CITY OF ALBANY
Public Works Department

ADDENDUM #1

ST-22-01, Queen Avenue Rehabilitation: City Limits to Pacific Blvd.

DATE: JANUARY 24, 2023

SHEET NO. 9 OF 107
 PROJECT NO: ST-22-01
 FILE: BASE.DWG

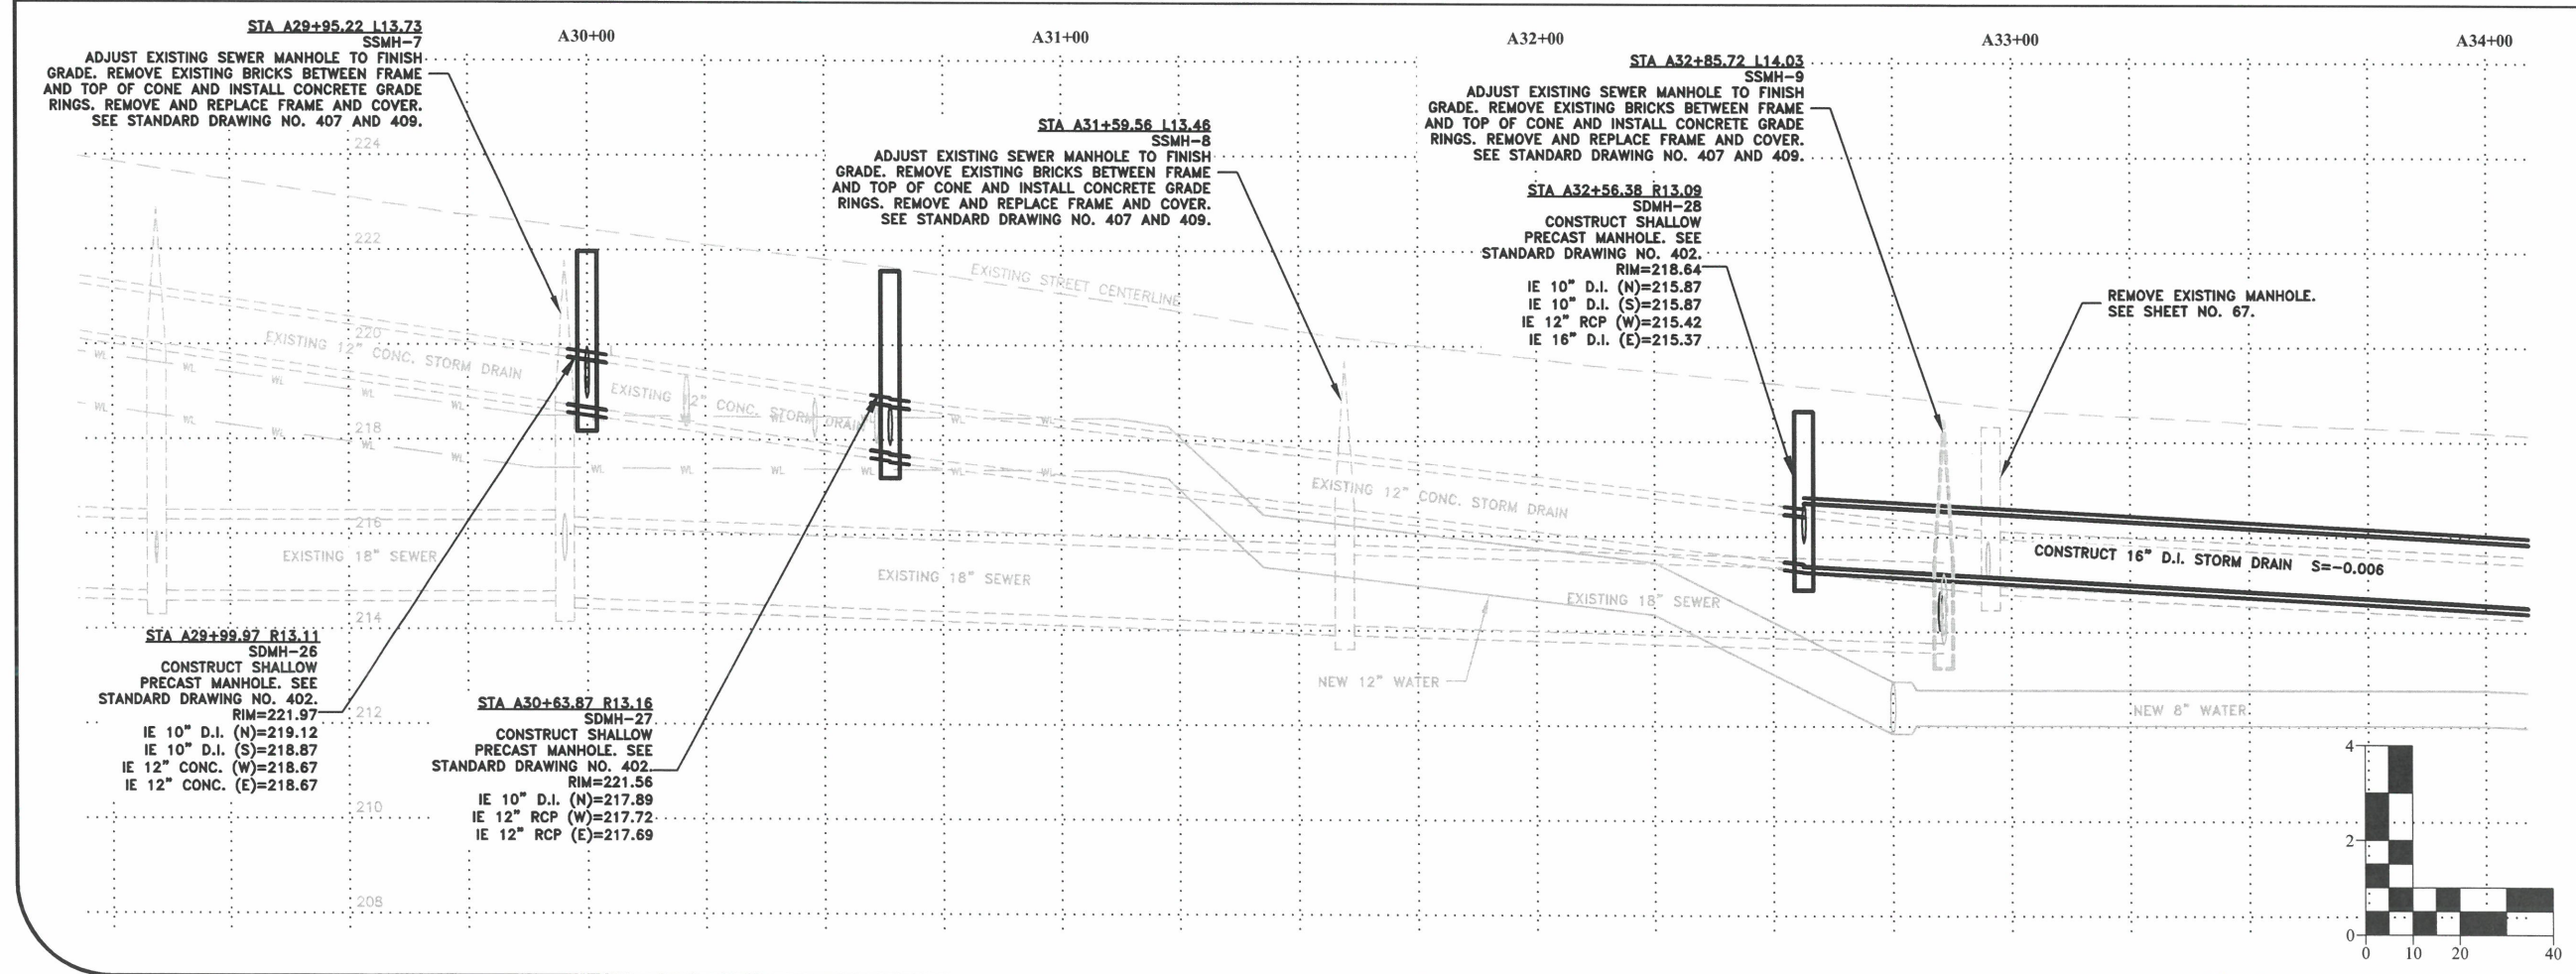
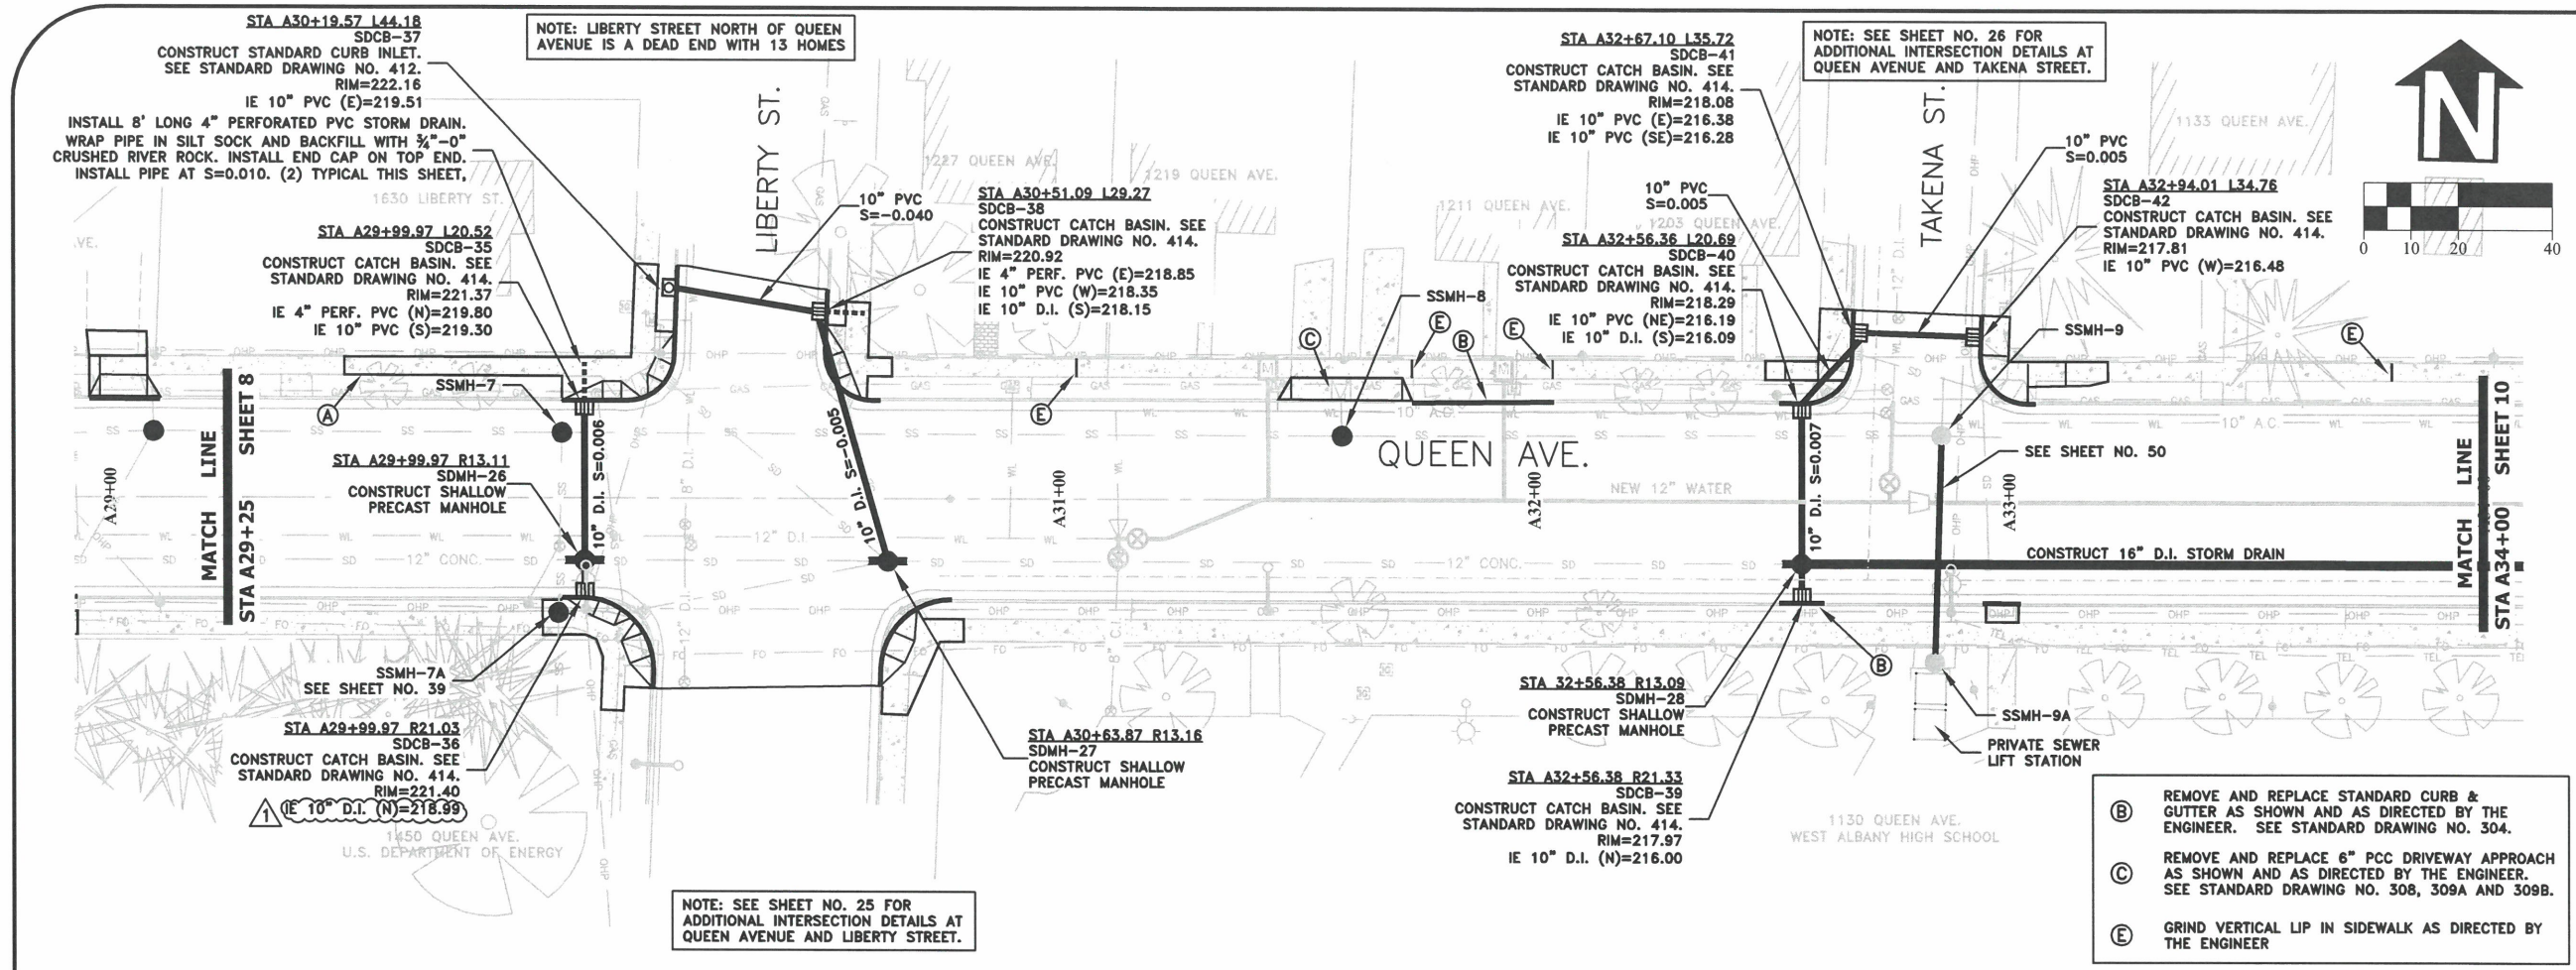
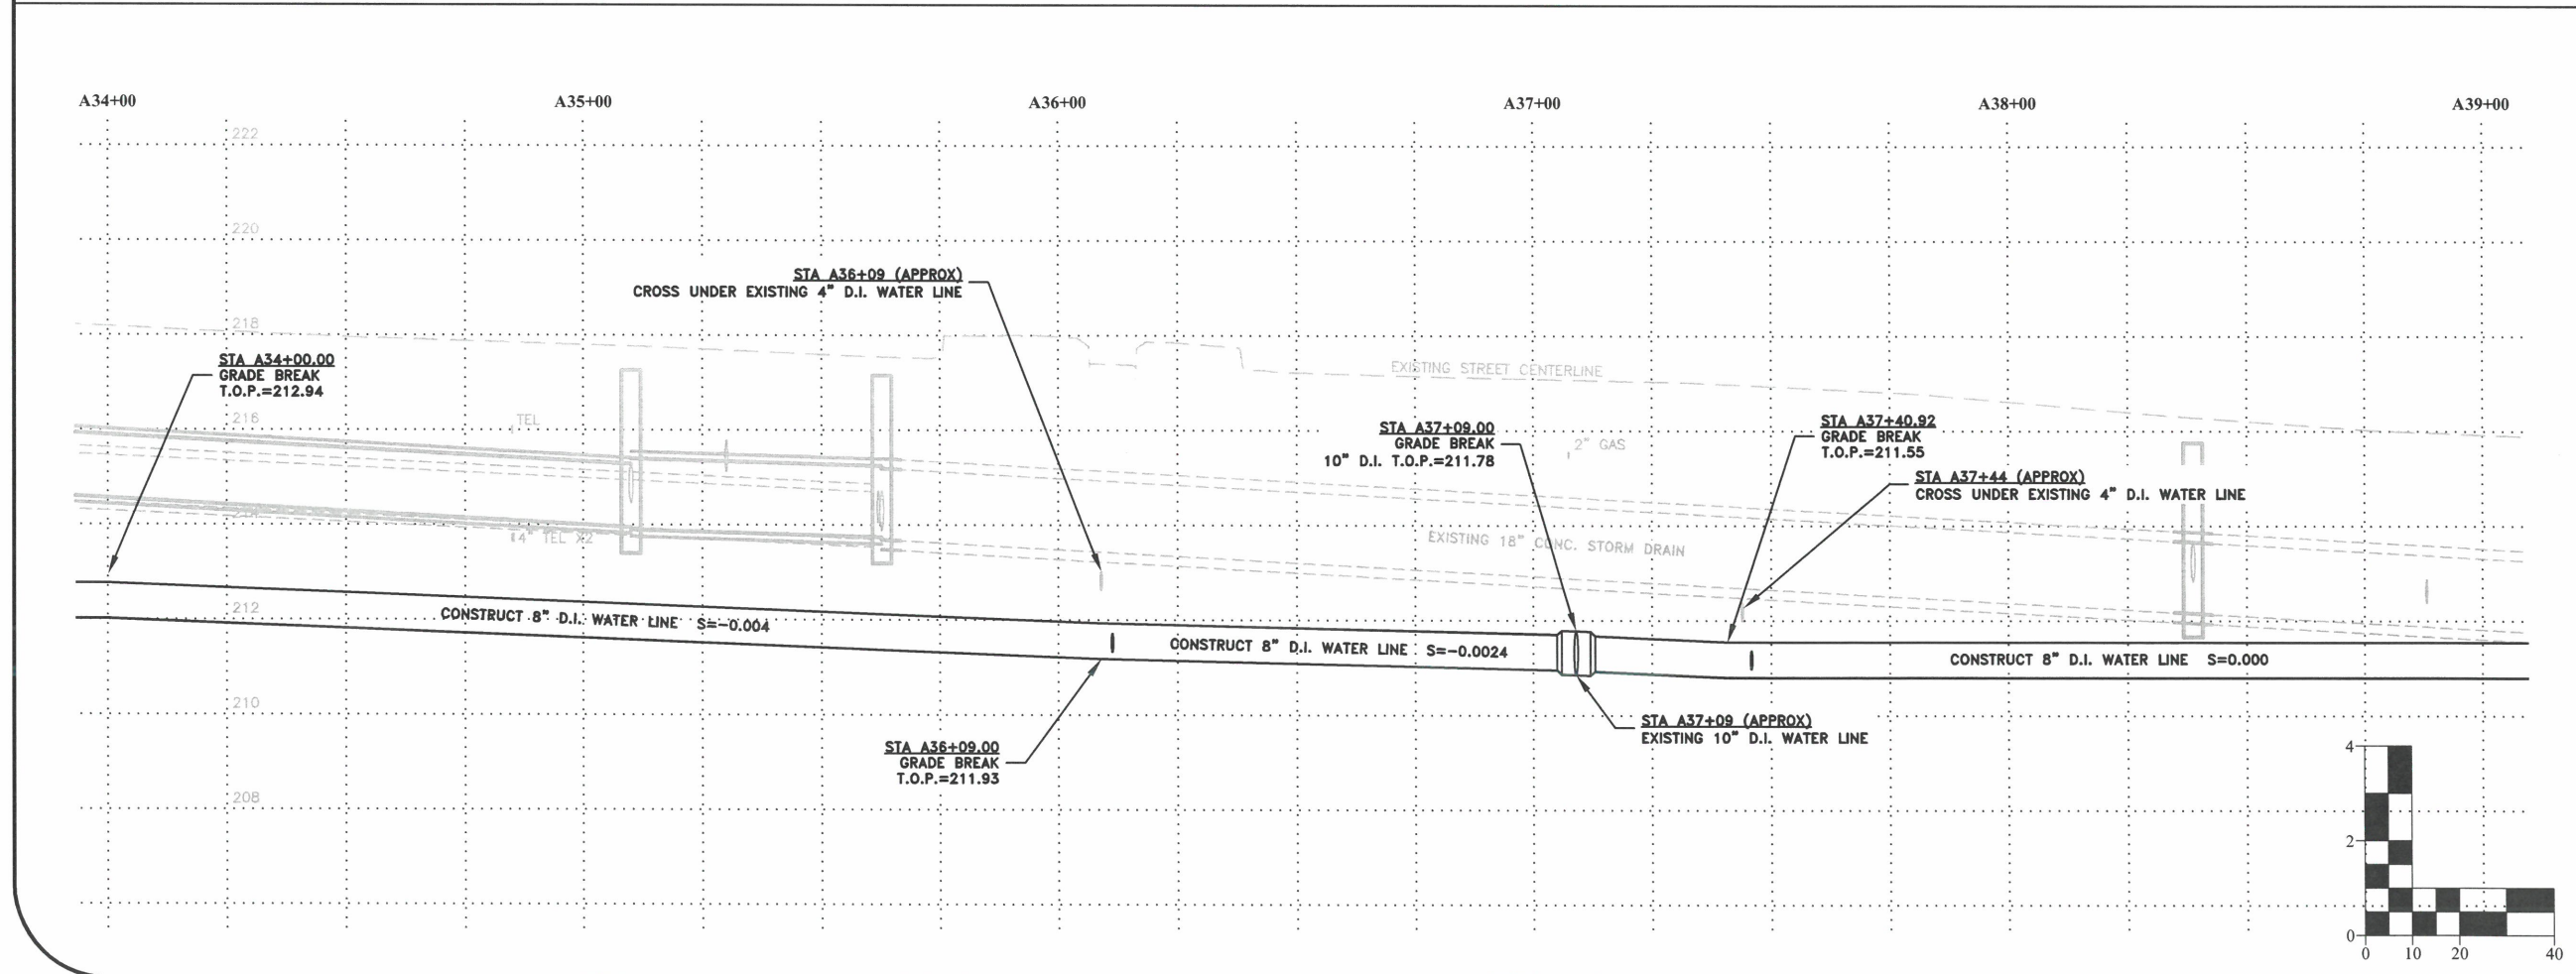
- Sheet No. 8: Updates pipe diameters for catch basin runs
- Sheet No. 9: Updates pipe between SDMH-26 and SDCB-35 is 10-inch ductile iron
- Sheet No. 40: Changes the two 4"x4" Connection Assemblies to be 8"x4" Connection Assemblies
